Rev. As-Built 3-23-89 TCR

PRIVATE SANITARY SEWER RELOCATION TO SERVE
LOT 2, BLOCK 2, GALYARDTS 5TH ADDITION

PROJECT NO.
468-76-245-80000-000-000-187

CITY OF WICHITA, KS.

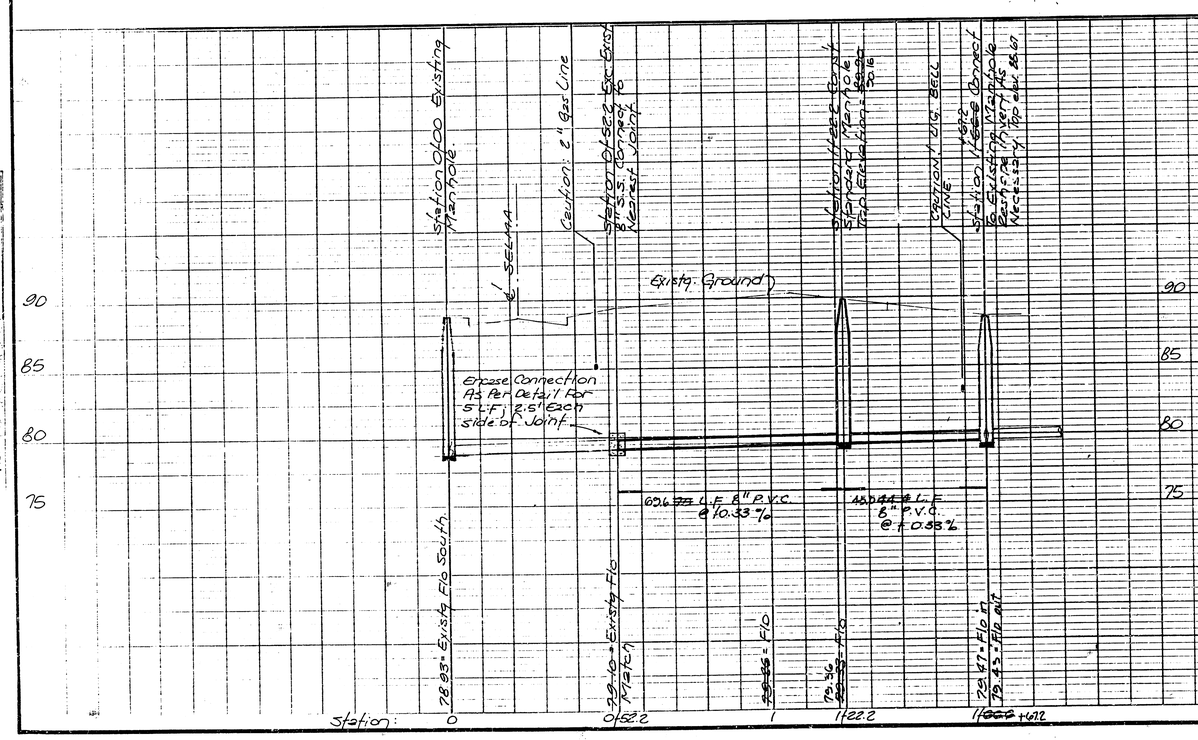
Station 1+67.2 ~~Cut~~ Connect To Existg. Manhole. Remove 5 L.F. Existg. 8" Line N. & Plug. Reshape Invert as Necessary.
